Memorandum

To: Salt Lake City Historic Landmark Commission

Re: **PLNHLC2021-01074 Madeleine Choir School Field House - New Construction**

PROPERTY ADDRESS: 67 N B Street
PARCEL ID: 09-31-382-002-2000 (All of Block 16, Plat "D" Salt Lake City Survey)
MASTER PLAN: Avenues
LOCAL HISTORIC DISTRICT: Avenues and SLC Landmark Site
ZONING DISTRICT: I – Institutional Zoning District

Figure 2 - 2nd Avenue Entrance Design with Accessible Parking Stall

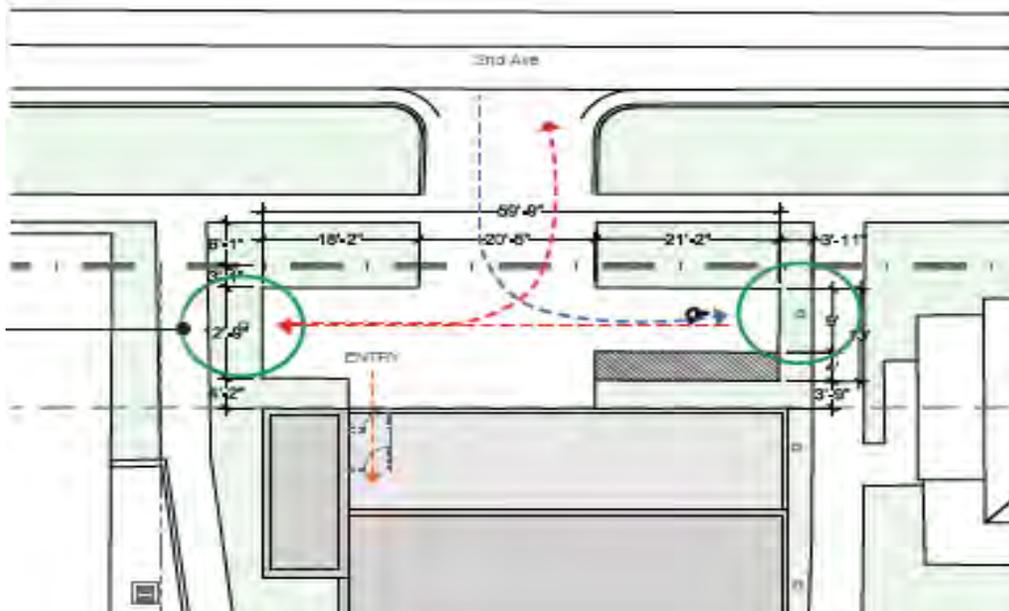
As initially proposed, the entrance lacked detail on its intended function and specific dimensions for any proposed parking. The applicants have clarified these aspects, as seen in Figure 2. Kevin

Young from the city's Transportation Division reviewed the proposal now under consideration and determined that the inclusion of one accessible parking stall at this entrance would meet dimensional standards ([See Attachment F – City Comments](#)).

However, the proposed design would utilize space within the required 20-foot yard setback. Front yard parking is not permitted within the I institutional zoning district and therefore, a modification is being requested to reduce the front yard setback to zero to accommodate the proposed ADA parking space. The I zone also requires the front yard to have at least 1/3 of the yard covered by vegetation. This standard would not apply with the request to reduce the front yard to zero, but it should be noted. The existing parking lot at this location also encroaches into the yard setback. Staff located a 1986 special exception approval for parking in this encroachment from the city's Board of Adjustment. In Staff's opinion, continuing to provide an accessible stall in this location is a desirable and necessary use. The current curb cut and driveway are sufficient for this limited use and would not require modification. The space will not function as a drop-off for parents and its primary use will be as a queuing area for the 2nd Avenue entrance. In addition, a continuation of this existing yard encroachment will allow the north facade of the building to be constructed to the 20-foot setback line. Staff will work with the applicants on the final design to include permeable pavers and appropriate landscaping in this area. Existing landscaping includes two trees that will be retained.

Figure 3 – Example of Nylon Netting and Posts Proposed for Roof Play Area. The example is much taller than proposed in this case.

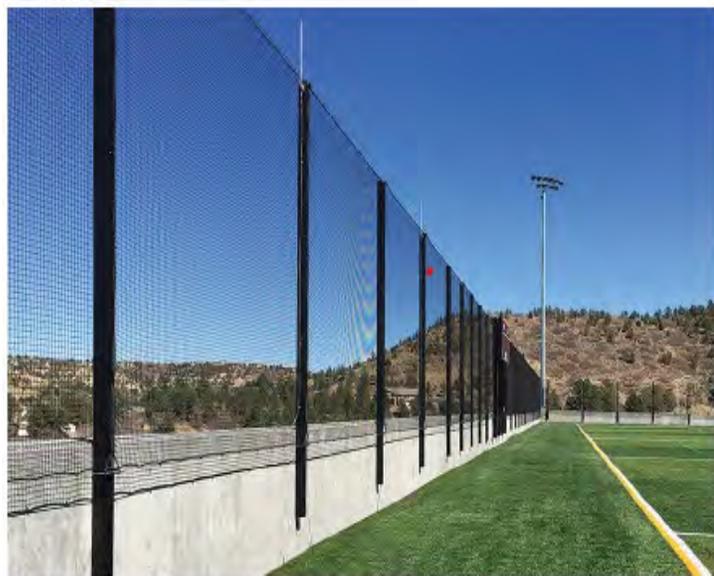
The proposed material of the safety screen is nylon netting. A similar use is pictured here, which shows a taller screen with the same material on the grounds of Judge Memorial Catholic High

School on 1100 East. Considering the setback and the relatively transparent quality of the netting material, Staff has found that the request for increased height will not have a detrimental visual impact on the streetscape, meets the standards of 21A.34.020, and is appropriate.

ENLARGED 2ND AVE PLAN

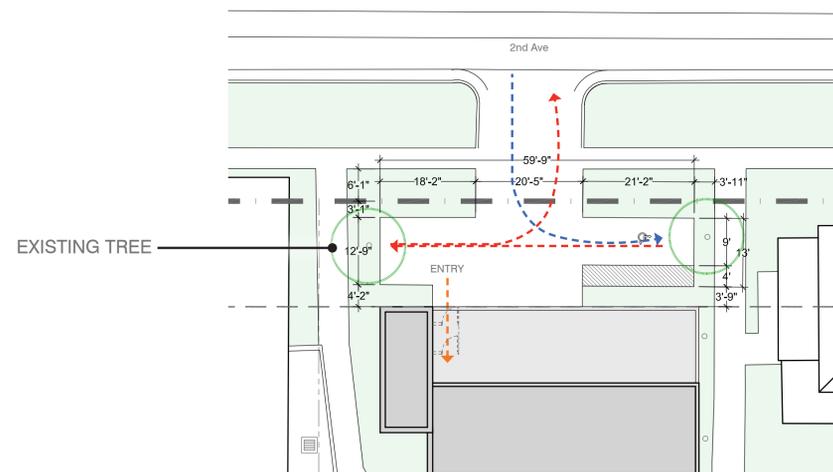
One ADA stall is proposed on the North Side of Early Childhood. There is currently an ADA stall at this location. This space would not function as a drop-off for parents, it would be utilized as ADA parking only (when necessary). The parking configuration would require the vehicle to pull into the ADA stall and when exiting back up straight using the 59'-9" dimension and then exit. See line work diagram.
